**Written submission from
Algonquins of Ontario**

**Decision on the scope of an environmental
assessment of the proposed Micro Modular
Reactor Project at the Canadian Nuclear
Laboratories Ltd., in Chalk River**

Subject: Request to Intervene and Submission of Comments on the Scope of Factors to be Considered in the Environmental Assessment (CEAA 2012) for the Micro Modular Reactor (MMR™) Project by Global First Power at the Chalk River Canadian Nuclear Laboratories Site (Our File CF 48-25)

Figure 5 - Sediment Sampling Locations near the NPDWF (CNL EIS, 2017)

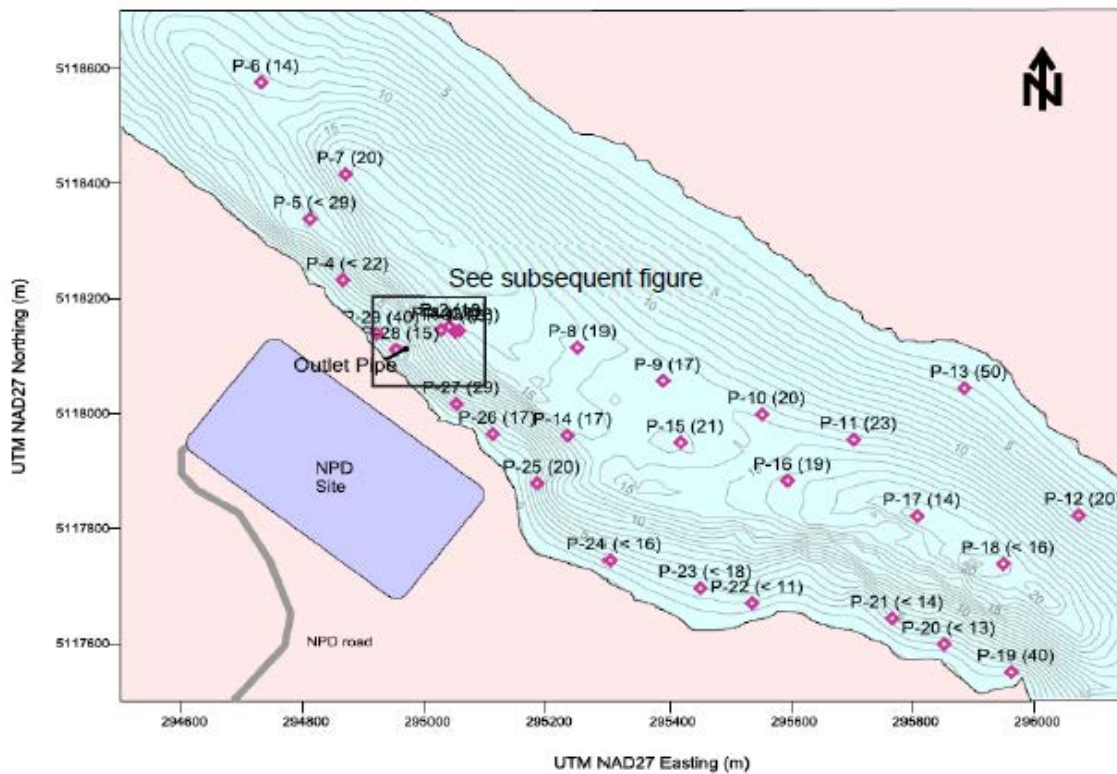
Water quality sampling on the Kitchissippi both upstream (near the Rapides de Joachim) and downstream (near the town of Deep River) of the NPD site show that levels of radioactive Tritium, Cs-137, and Sr-90 are comparable. These values are well below the guidelines for Maximum Allowable Concentration from Health Canada (2017). Sediment samples were collected in 2014 from the Kitchissippi near the outlet of the process drain (Figure 5). Radionuclide concentrations (Bk/kg) for several contaminants were measured. Sediment samples were collected and tested for non-radiological contaminants in 2016. Results of this testing showed average values all below CCME Interim Sediment Quality Guidelines.
